REACTOR COOLANT SYSTEM INSERVICE HYDROSTATIC TEST HEATUP AND COOLDOWN LIMITATIONS APPLICABLE FOR FIRST 5.0 EFFECTIVE FULL POWER YEARS

SAFETY EVALUATION BY THE OFFICE OF NUCLEAR REACTOR REGULATION
SUPPORTING AMENDMENT NO. 28 TO FACILITY OPERATING LICENSE NO. DPR-51
ARKANSAS POWER & LIGHT COMPANY
ARKANSAS NUCLEAR ONE - UNIT 1
DOCKET NO. 50-313

NOTICE OF ISSUANCE OF AMENDMENT TO FACILITY
OPERATING LICENSE

Figure 3.1.2-1

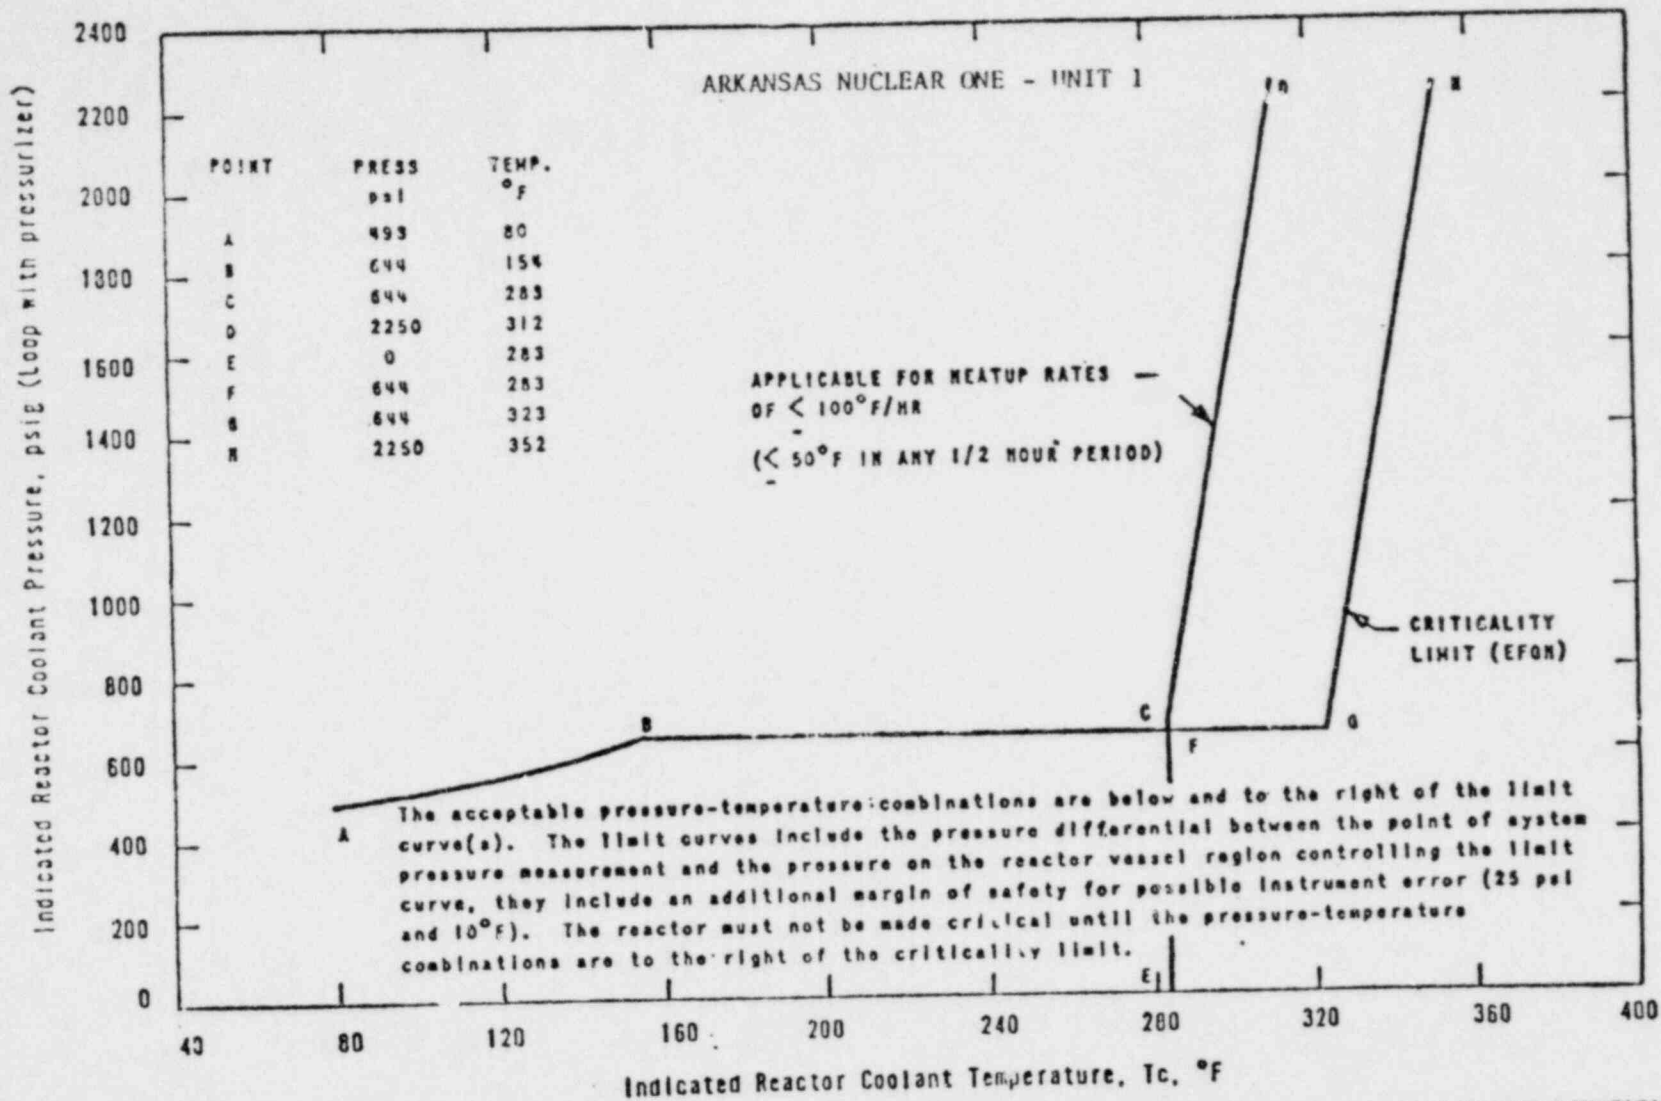
By letter dated July 8, 1977, (with supportive document BAW-1440), Arkansas Power & Light Company (AP&L) requested changes to the Technical Specification pressure-temperature limit curves for hydrostatic test, normal heatup, and normal cooldown for Arkansas Nuclear One - Unit 1 (ANO-1). This change was required by Technical Specification 3.1.2.7 and was accompanied by the aforementioned Babcock and Wilcox Company document BAW-1440, which detailed the analysis performed by Babcock and Wilcox on ANO-1 surveillance capsule ANI-E. The surveillance capsule had been withdrawn in the Spring of 1976. During our review we determined that certain changes to the proposed specifications were necessary to meet our requirements. These changes were discussed with and agreed to by the AP&L staff and have been incorporated.

As noted in BAW-1440, the specimens in Capsule ANI-E were analyzed by Babcock and Wilcox after withdrawal from the ANO-1 vessel in the Spring of 1976. Such capsules are monitored over the life of the reactor vessel to predict the effects of radiation on the fracture toughness properties of the vessel materials. The results are used in the revision of pressure-temperature limit curves in the Technical Specifications. Adherence to the revised curves will provide assurance that no brittle failure of the reactor vessel will occur.

The specimens in Capsule ANI-E received a neutron fluence of 7.27×10^{17} n/cm² (neutrons per square centimeter). The test results indicated that vessel weld material is the limiting material. For this weld material, irradiation produced a shift

in RT_{NDT} (as defined in paragraph NB-2331 of the ASME Code) of 137°F at the 50 foot-pound level, and a drop in upper-shelf Charpy energy from 70 to 55 foot-pounds. The drop in upper shelf energy is consistent with predicted values of USNRC Regulatory Guide 1.99, Revision 1. However, the shift in RT_{NDT} is larger than the upper limit predictions of the Regulatory Guide. The test results on correlation material specimens contained in the capsule also show a slightly higher amount of radiation damage than has resulted from similar surveillance programs. These correlation materials are part of a research program funded by the NRC and known as the Heavy Section Steel Technology (HSST) program. The specific specimens were designated HSST-PL-02.

AP&L proposed that the revised pressure-temperature limit curves be effective through the end of eight (8) EFPY (effective full power years). This proposal was based upon the RT_{NDT} upper limit adjustment line contained in Regulatory Guide 1.99. However, the NRC staff concluded that, because the shift in RT_{NDT} is greater than that predicted by the upper limit line, the temperature shift should be calculated by extrapolating the surveillance data point parallel to the prediction lines in Regulatory Guide 1.99. This method led to the conclusion that the revised curves would be acceptable through the first five (5) EFPY instead of the eight EFPY limit proposed. AP&L accepted this change, which has been incorporated.

We have concluded that the proposed changes, as modified, are acceptable and are in conformance with Appendix G to Title 10, Code of Federal Regulations, Part 50 (10 CFR 50). Conformance with Appendix G of 10 CFR 50 in establishing operating limitations will assure adequate safety margins during operation, testing, maintenance, and postulated accident conditions and constitute an acceptable basis for satisfying the requirements of NRC General Design Criterion 31 (10 CFR 50, Appendix A).
